# **Flawed Reactor Pressure Vessels in Belgian Nuclear Plants Doel-3 and Tihange-2**

*Some Comments on the  
FANC Provisional evaluation report (January 30, 2013)*

Ilse Tweer

March 2013

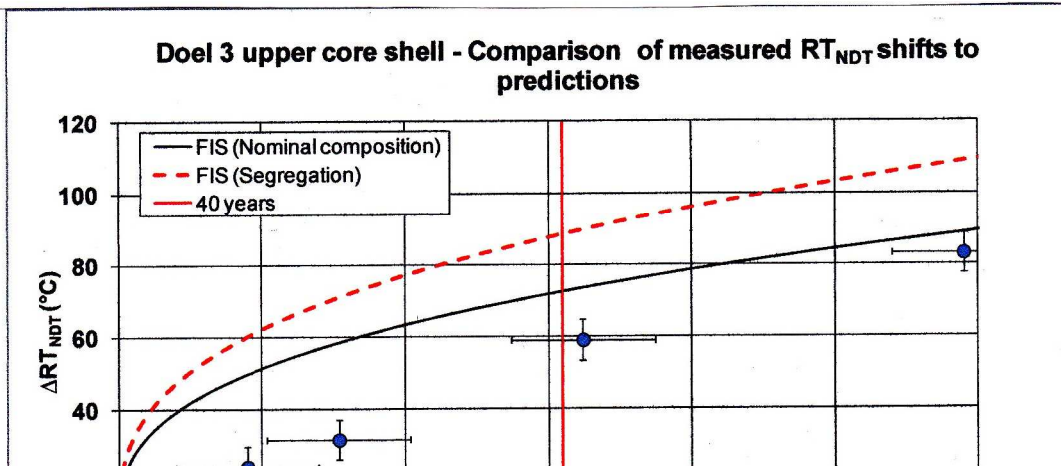
Due to the fact that no information exists on radiation embrittlement materials containing hydrogen-related defects Electrabel has proposed to add 50°C to  $RT_{NDT}$  “on top of the irradiation effect”. Electrabel considers this procedure as “very conservative”<sup>42</sup> (emphasis added by the author).

For end-of-life  $RT_{NDT}$  (FIS) is about 73°C (in case of Doel 3), with the additional 50°C the resulting  $RT_{NDT}^{(FIS+50)}$  would be **about 123°C** (see figure 1).

For end-of-life the resulting  $RT_{NDT}$  (for Doel 3) including the 50°C shift would be 106.5°C (Electrabel document, page 82) as can be seen in the following figure:
